Horizon

Lee 5 Honeysuckle

Design Report

This design report illustrates the design process with feedback and commentary from the panel.

4.1 State Design Review Panel Meeting 03

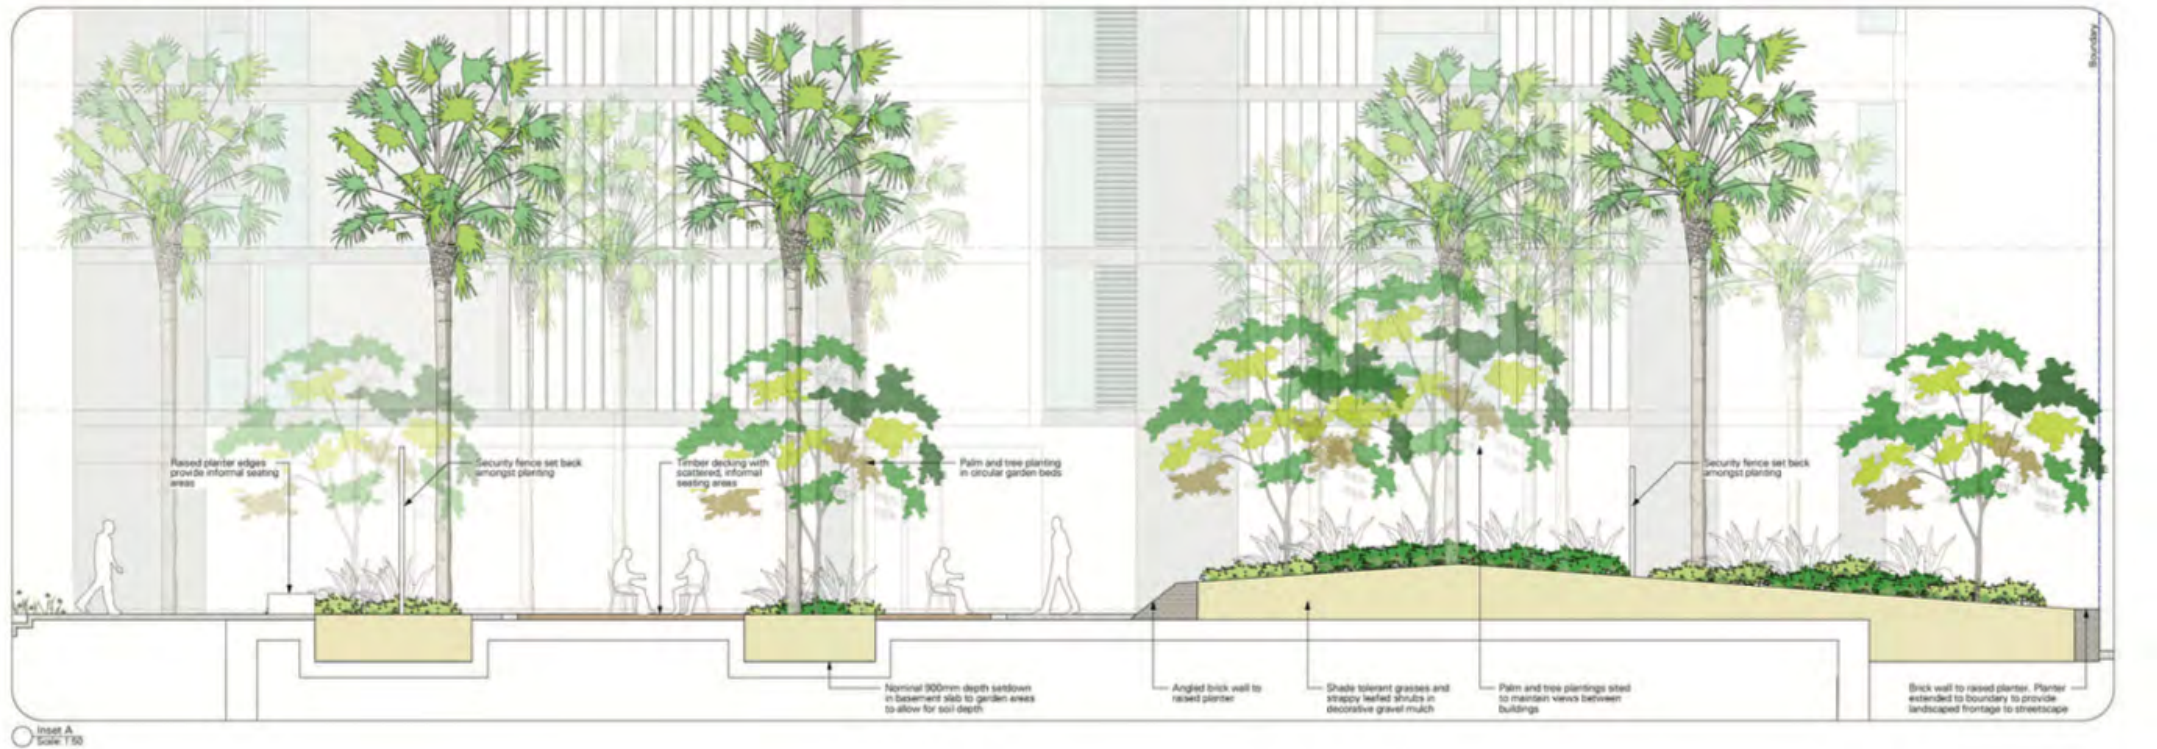
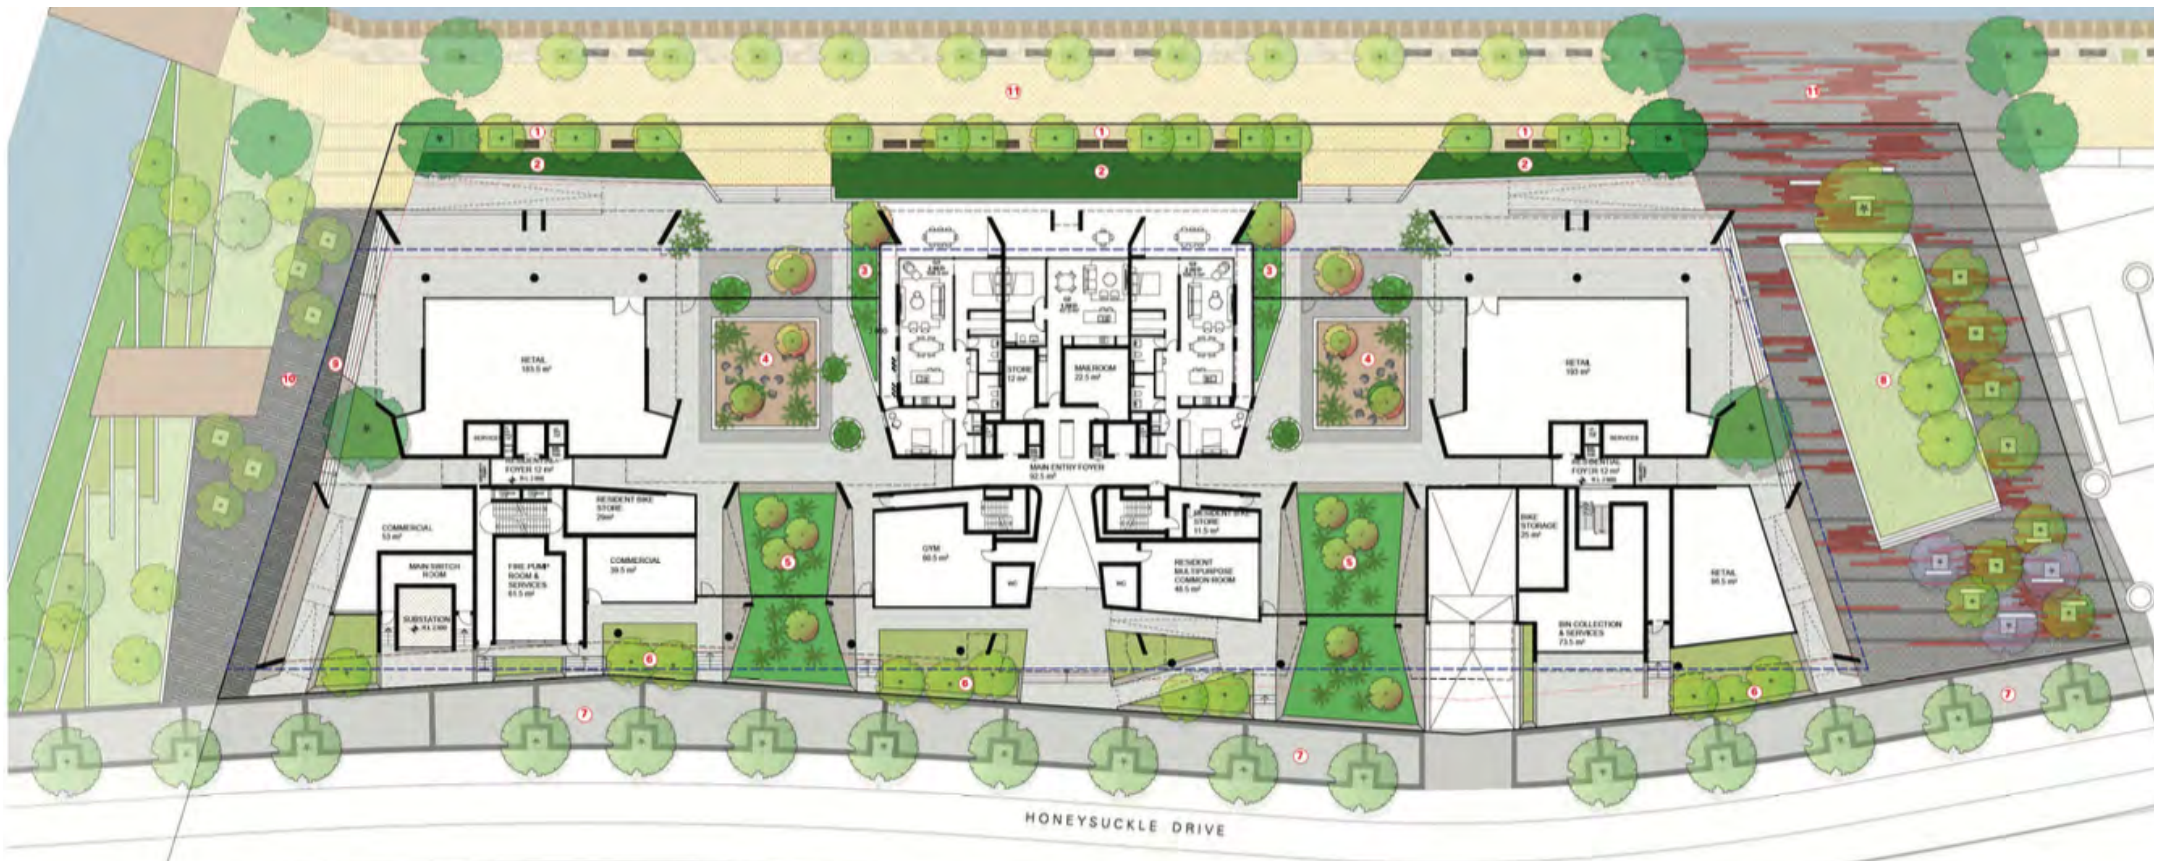
The panel noted that the amendments to the scheme since the previous review are generally supported. The generosity to the public domain and integration of landscape, the proposed expression of plinth and brick materiality, and the modulation of the skyline created by the additional height at the western end are supported.

4.4 Ground Plane

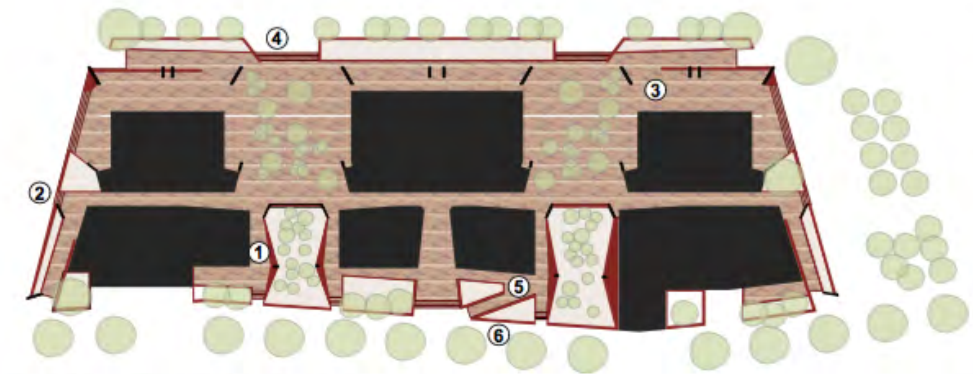
The ground plane was developed further in relation to form and materiality. The panel supported the brick plinth strategy and an successful treatment to unify the ground plane.
